18-050

Agenda Date: 3/6/2018

### REPORT TO COUNCIL

1075 Pomeroy Avenue Four Units Development Project

3 PROPOSED TYPE A & A1 WEST ELEVATION  
SCALE: 3/16" = 1'-0"

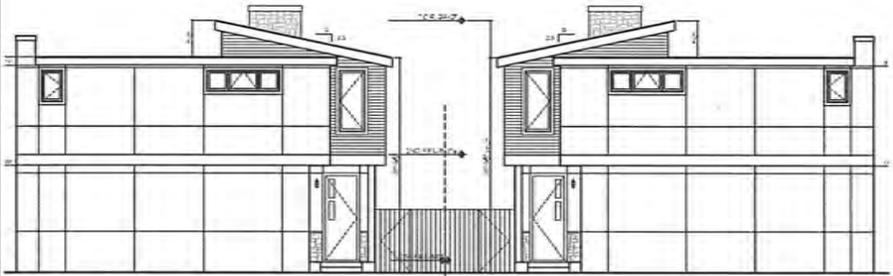
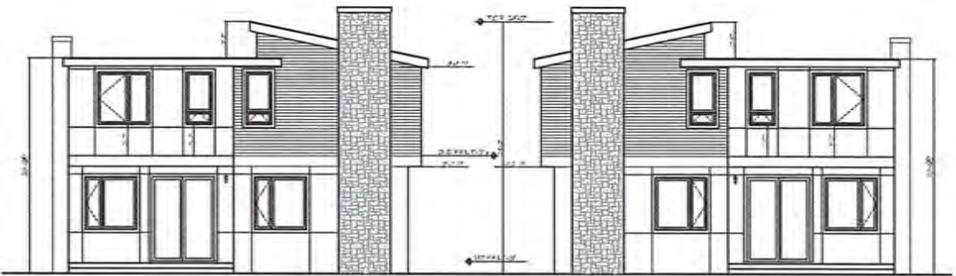
I also request you have the developer's architect correct his plans and then allow the public and I more time to review the corrected plans. There are some significant labeling errors on the plans; I discovered in the labeling of the elevation drawings. The "Proposed Type A & A1 West Elevation" drawing, detail # 3, on page A1B, is actually a west elevation of proposed type "B" and "B1".

Also, the “Proposed Type A & A1 East Elevation” drawing, detail 4 on drawing A1B, is actually the east elevation of the proposed type “B” and “B1”.

C-4 The commenter is referencing titles and numbers that do not correspond to the elevation figures (Figures 6 through 9) presented in the IS/MND, and the labels on the figures appear to be correct. However, in the event that one of the elevations is designated "west" when it should be designated "east," this would be a minor clerical error and would not materially affect the analysis of environmental effects presented in the IS/MND.
